RE: New Gath Pool depth analysis

project name & number: Gath Pool Improvements
BH+A Project No. 3457

subject: Lap Pool Depth Study

LAP POOL DEPTH OPTION 1

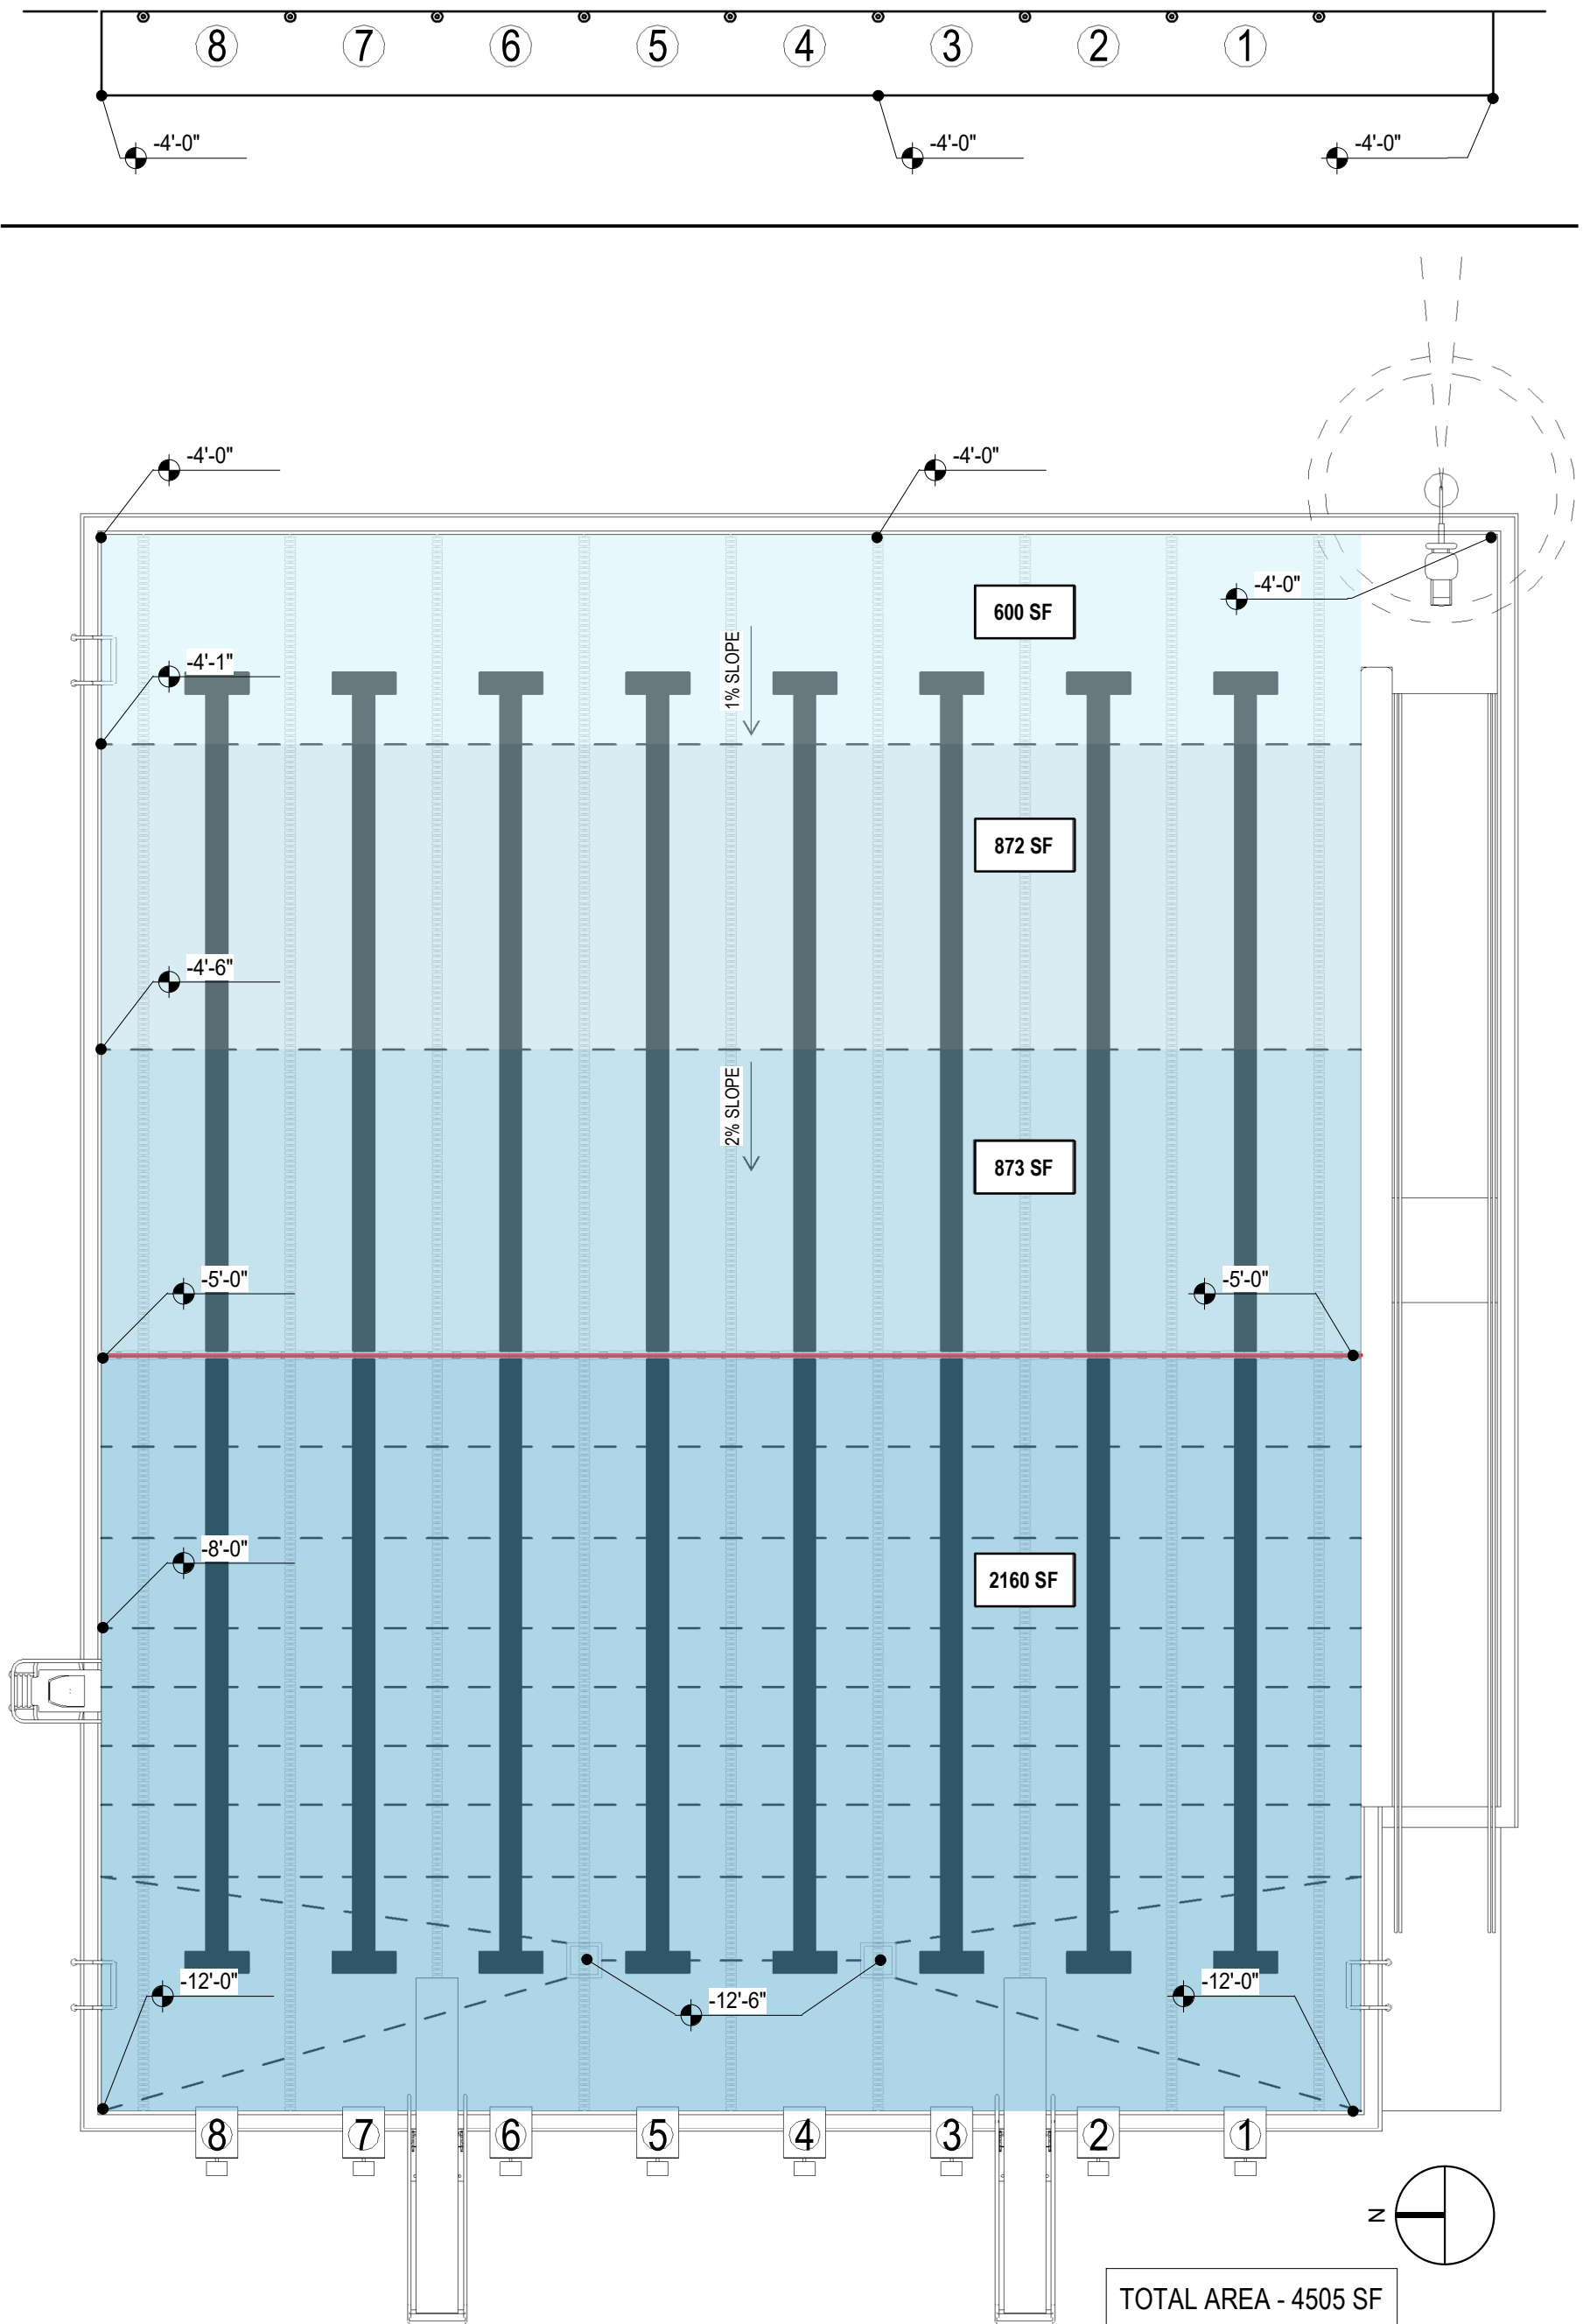
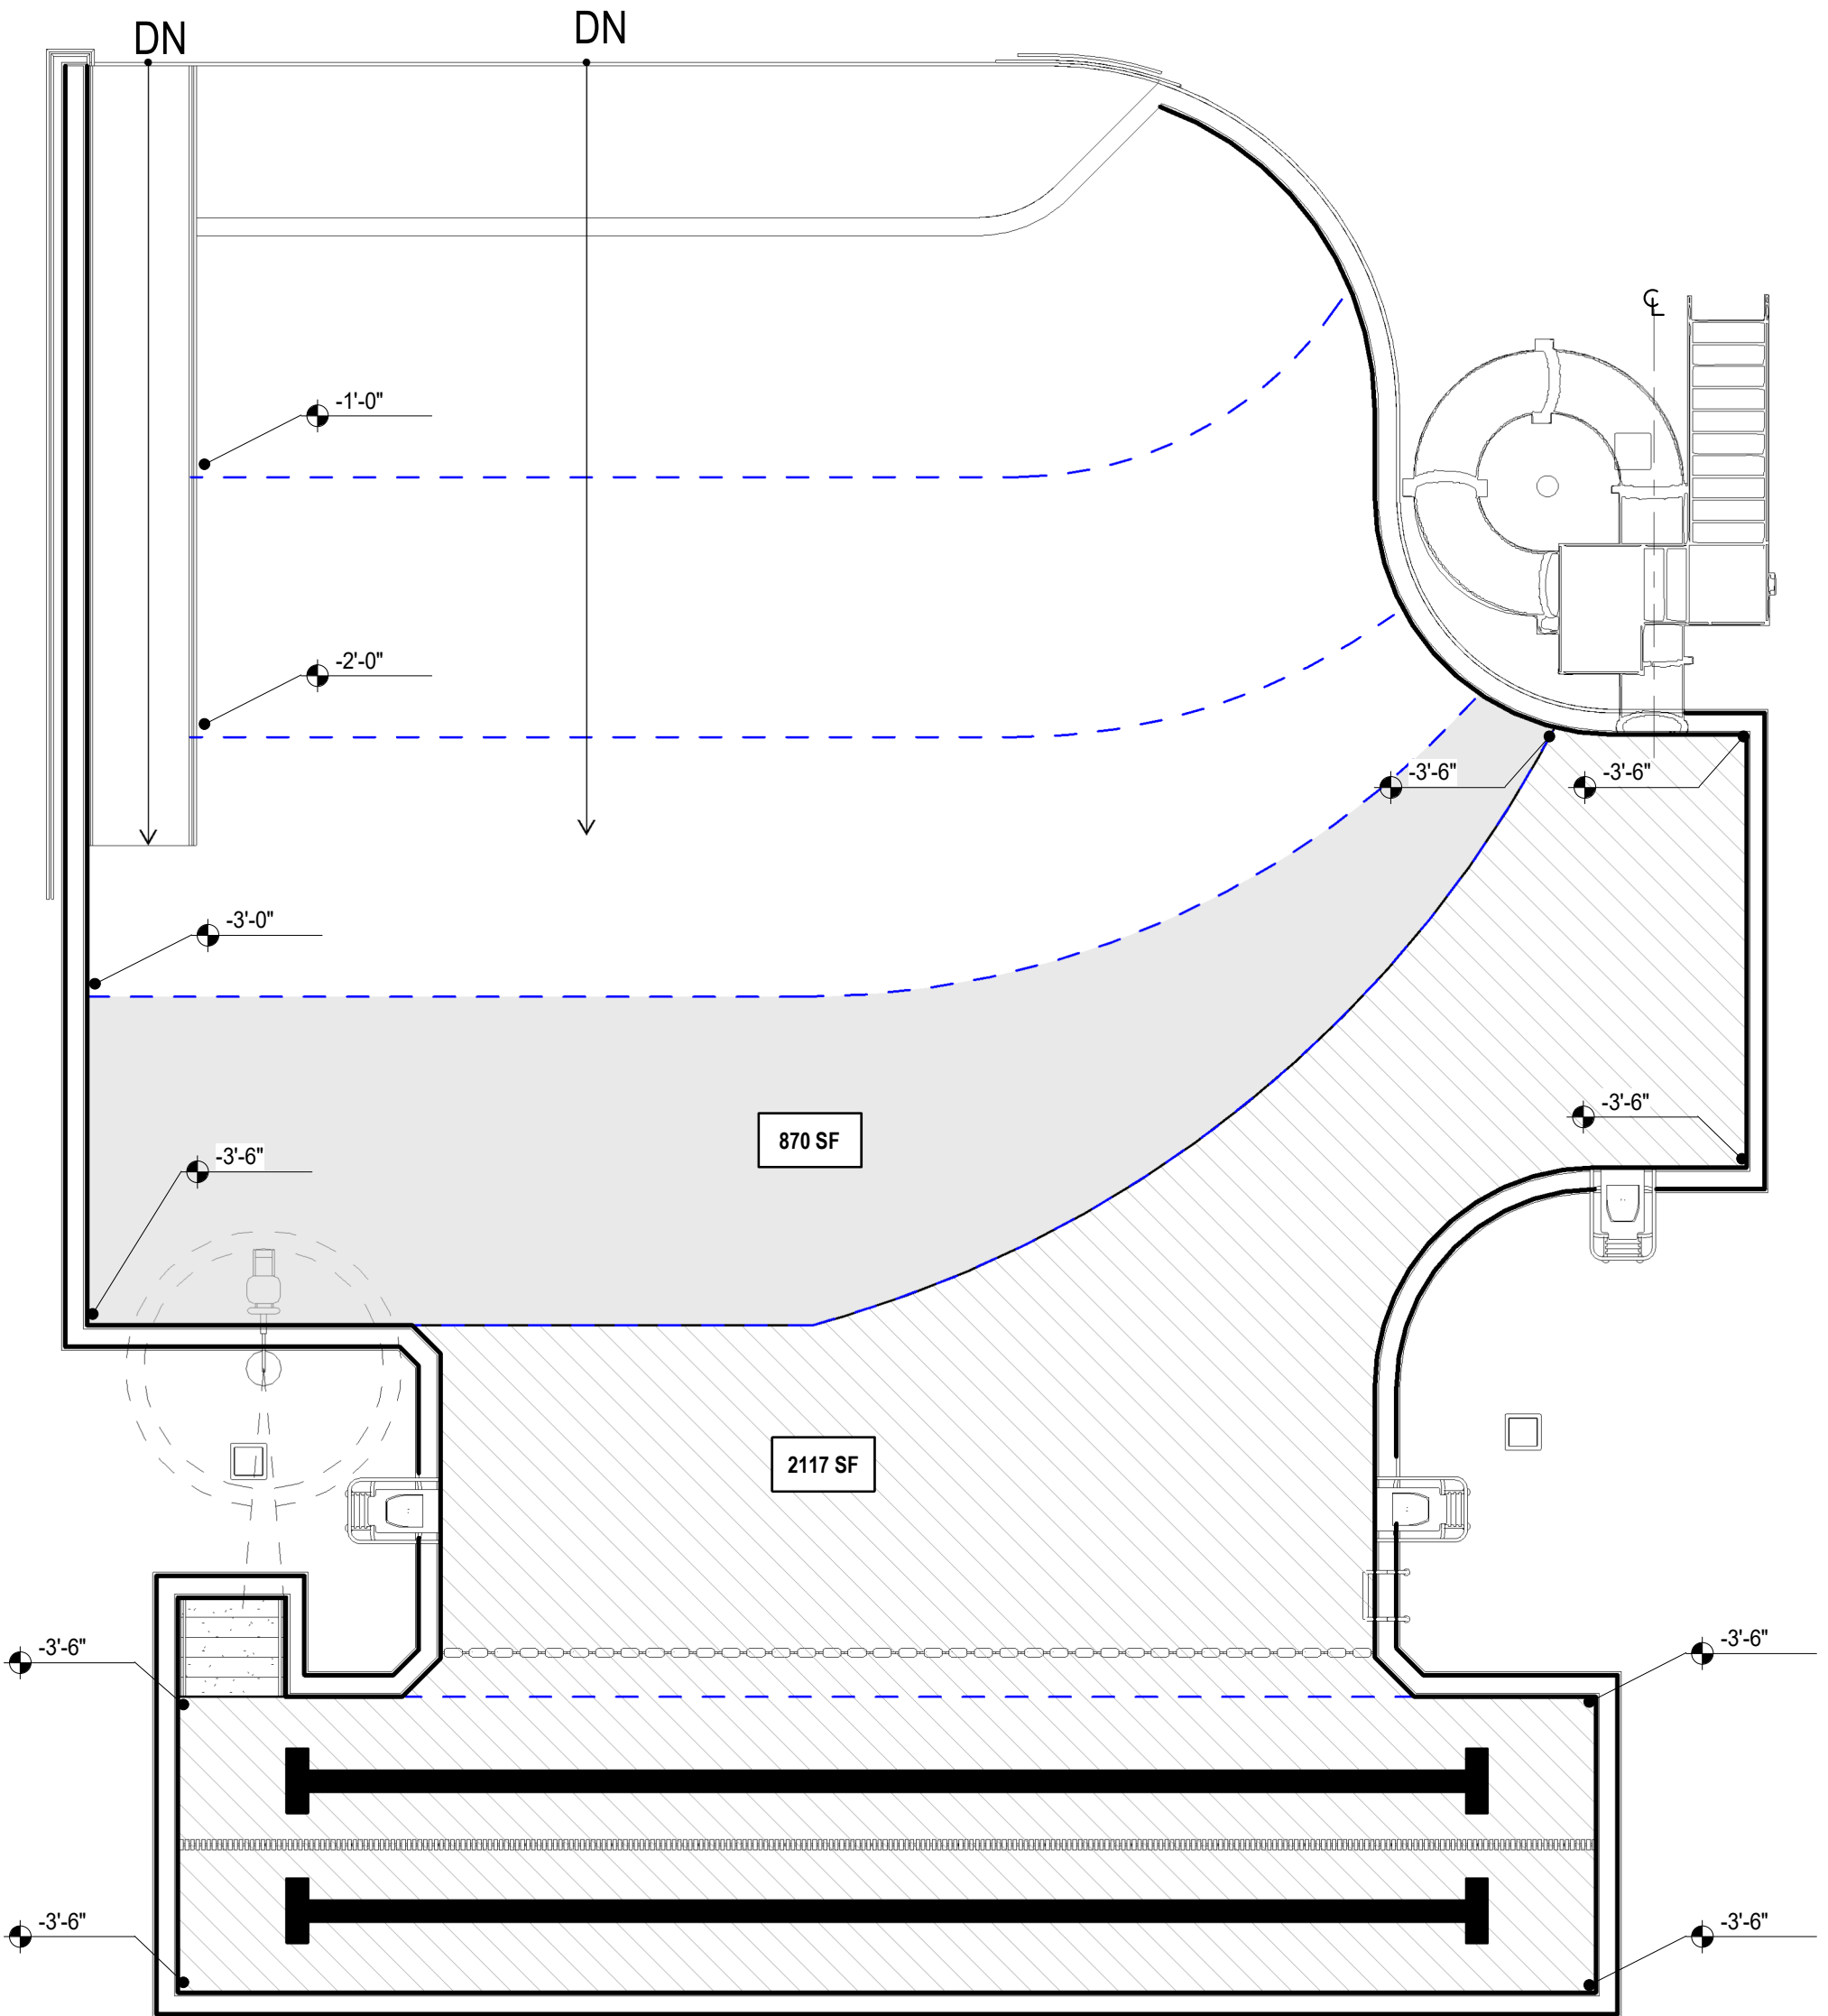
As requested, we have developed an option to increase the pool depth at the shallow end of the lap pool. The pool depth would be 4 feet at the entry side of the pool and descend to 6'-7" at the northeast corner.

- The shallow wall drops from 4 feet at lane 1 to 6'-7" at the northeast corner of lane 8.
- A 1% slope is maintained at the shallow end of lanes 1 and 2. The area shown shaded is 304 SF.
- The remainder of the non-swimming area slopes between 5 & 7%. This area is shown with a diagonal cross hatch. The area is 1,140 SF.
- Lanes 5 and 6 slope from 5 ft. to 6 ft.
- Lanes 7 and 8 slope from 6 ft. to 6'-7".
- The bottom of the pool has a continuous 12 ft. depth around the perimeter, the main drains are set at 12"-6" inches to ensure full drain down of the pool.
- The bottom tile lane markings are uniform in lanes 1 and 2; the markings in lanes 3 to 8 perpendicular to the floor bottom slope. The slope is shallow and the lane markers will be clearly visible to swimmers. This condition is typical in many swimming pools.
